## Historic Preservation Commission

**HPC 20252779 - 1076 Canton Street - Certificate of Appropriateness for the demolition of an existing historic structure, to be followed by the reconstruction of the building, using historic materials**

Re: HPC Design Plan Application – Ten Seventy Six Club revised design  
Roswell, Georgia  
RPA Project No. 2021112.10

Figure 1. Proposed front elevation, note taller roof line exceeding the roofline of the reconstructed core (rendering from applicant)

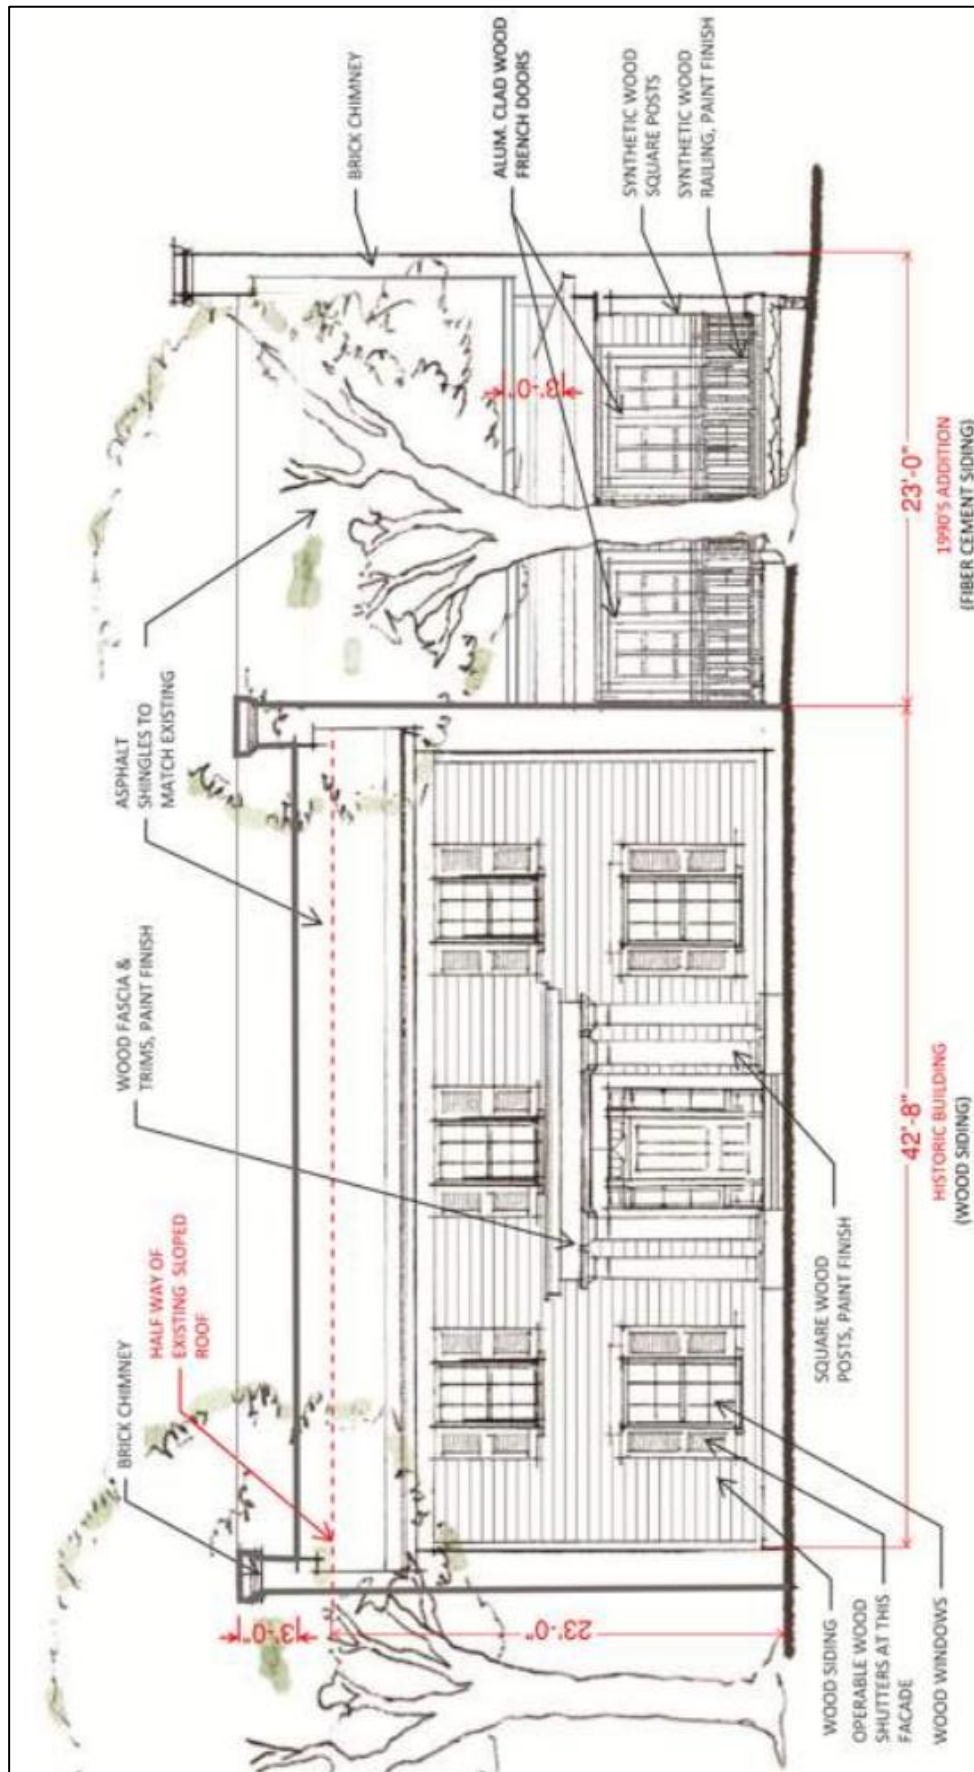
**5.3.10.4** – Requires that commercial houses in DX provide 20% ground floor and upper floor transparency. Because this would be considered a new building, even if it is being rebuilt with salvaged historical materials, the current transparency requirements of the UDC must be followed. The ground-floor and upper-floor transparency are currently both approximately 12%.

3. Raised planting beds or vertical trellises must be placed on the front wall of the ground floor of the structure, to be approved as an HPC administrative application, or a variance must be approved for the insufficient transparency on the lower level, lowering the requirement from 20% to 12%;

Figure 5. Site plan (plan from applicant)

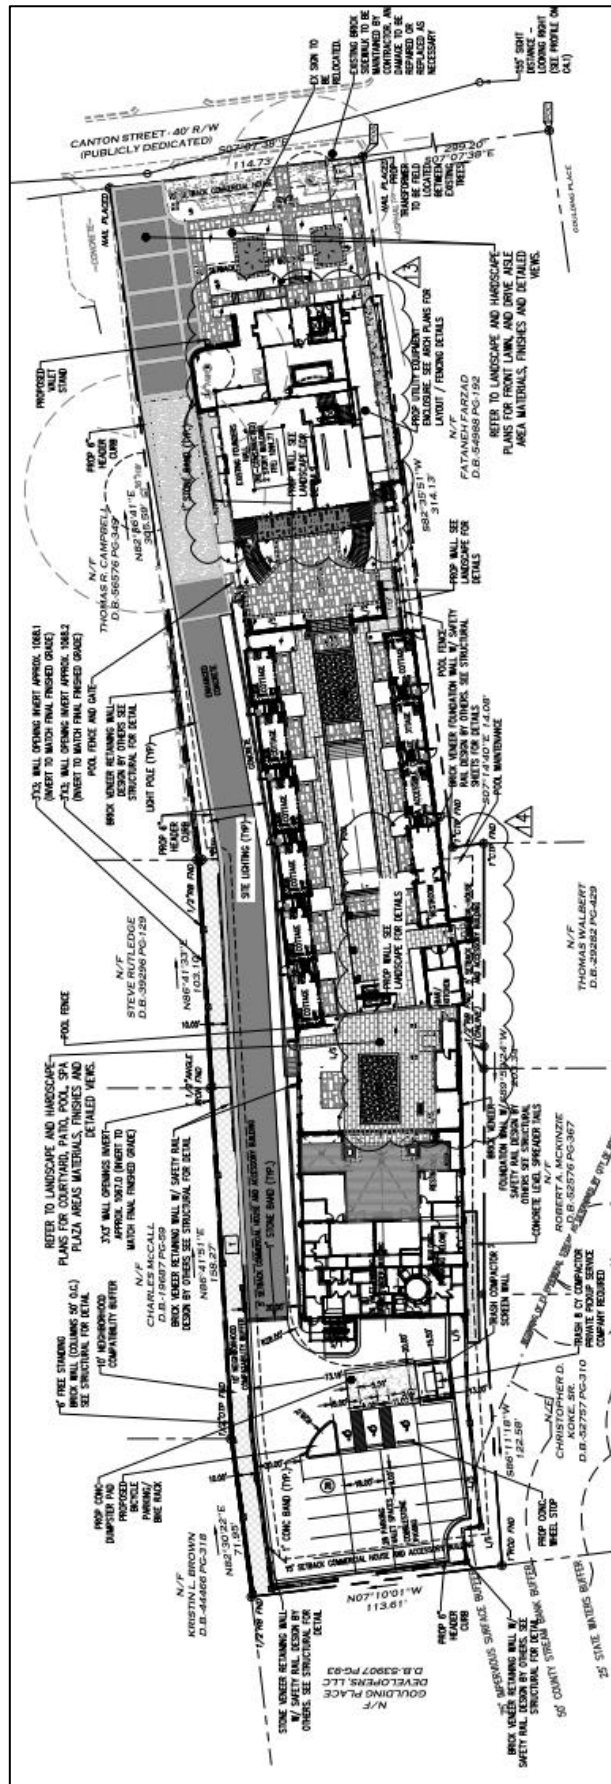
**5.3.10.2** – Requires that commercial houses in DX provide 5-foot side interior setbacks. There is a fenced-in area that is not very well marked on the plans, applicants should more properly denote what is going to be within this fenced area.

5. Applicants must provide Staff with details of any and all structures and objects being placed in the setbacks within the proposed fenced enclosure on the South-side of the primary structure;
